Access Compliance Report

Public Rights-of-Way

Intersection ID: 19029	Main Street: SHARON_LN	Cross Street: FOXCROFT_RD	Location: SW
ADA ID: 6301F9768C10	Ramp Type: ParaDiag	Initial Pass/Fail: Fail	Overall Compliance: No
Codes/Mitigation Info/Possible Solution		Field Measurements/Component Compliance	
Severity Score: 26.25

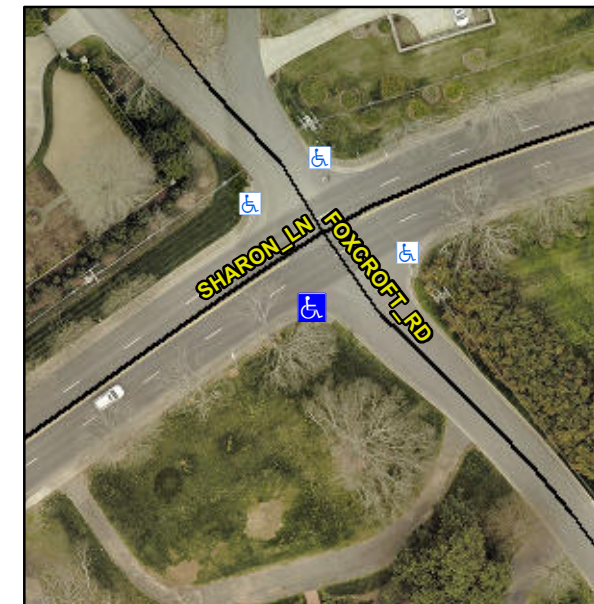
LT RP < 5%

R304.3.2, R304.5.3

Compliance	Description	Data	Compliance	Description	Data
N/A	Ramp Length LT (in)	56.0	N/A	Ramp Length RT (in)	40.0
Yes	Ramp Width LT (in)	51.0	Yes	Ramp Width RT (in)	51.0
Yes	Ramp Slope LT (%)	0.4	No	Ramp Slope RT (%)	12.4
Yes	Ramp XSlope LT (%)	1.5	No	Ramp XSlope RT (%)	4.1
N/A	Landing Length (in)	N/A	N/A	DWS Provided?	N/A
N/A	Landing Width (in)	N/A	N/A	DWS Contrast?	N/A
N/A	Landing Slope (%)	N/A	N/A	DWS Length (in)	N/A
N/A	Landing X Slope (%)	N/A	N/A	DWS Full Width?	N/A
N/A	Landing Curb? (Y/N)	N/A	N/A	DWS Offset (in)	N/A
N/A	Shared Landing?	N/A			
N/A	Gutter Ponding?	N/A	N/A	Gutter Slope (%)	N/A
N/A	Gutter Lip Ht (in)	N/A	N/A	Gutter X Slope (%)	N/A
N/A	Painted X Walk1?	No	N/A	Painted X Walk2?	No
	X Walk 1 Direction	To NE		X Walk 2 Direction	To NW
N/A	X Walk 1 Width (in)	N/A	N/A	X Walk 2 Width (in)	N/A
	X Walk 1 Slope (%)	4.7		X Walk 2 Slope (%)	8.8
	X Walk 1 X Slope (%)	6.4		X Walk 2 X Slope (%)	1.1
N/A	Ramp inside XWalk1?	N/A	N/A	Ramp inside XWalk2?	N/A

Remove & Replace Curb Ramp With Two New Directional Ramps or Equivalent.
